ADDENDUM TWO CITYWIDE ROW CONCRETE CONTRACT CONTRACT NO. T-16-003-201 CITY OF CHATTANOOGA, TENNESSEE

The following changes shall be made to the Contract Documents, Specifications, and Drawings:

CONCRETE STEPS

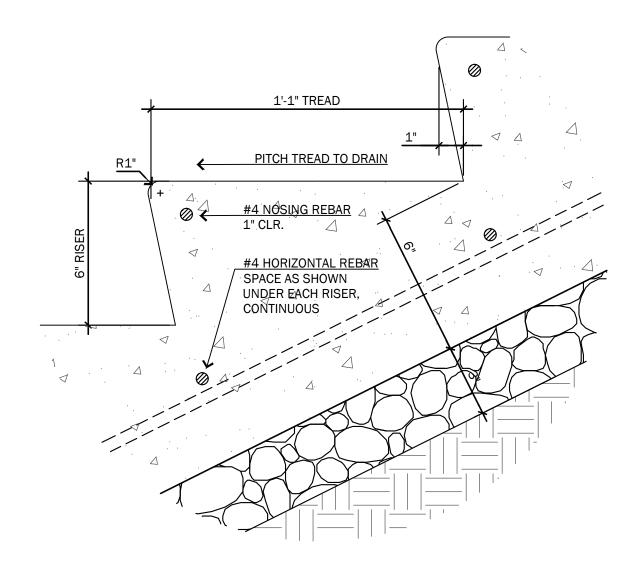
- Concrete Steps Detail
- Typical Step Detail
- Typical Handrail Detail
- Wall Detail
